**National Fire Protection Association**

**SUBJECT:** NFPA 1801 ROP TCC Letter Ballot (A2012)

In accordance with the NFPA Regulations Governing Committee Projects, attached is the Letter Ballot on the Report on Proposals (ROP) for the 2013 Edition of NFPA 1801.

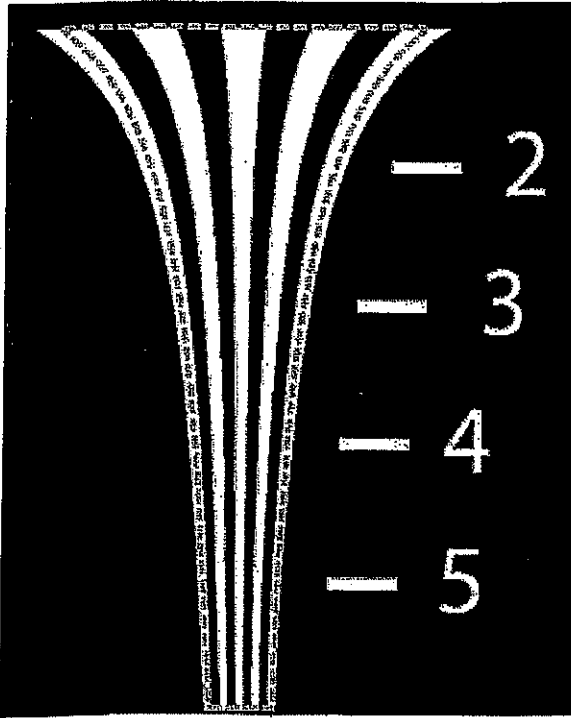
8.10.7.7 and 8.10.8 The parts of the Effective Temperature Range Test that involve testing for pixel saturation should be removed because they result in erroneous information.

8.12.4.6 The reference to the combined area of the emitting surface is incorrect, and should be deleted.
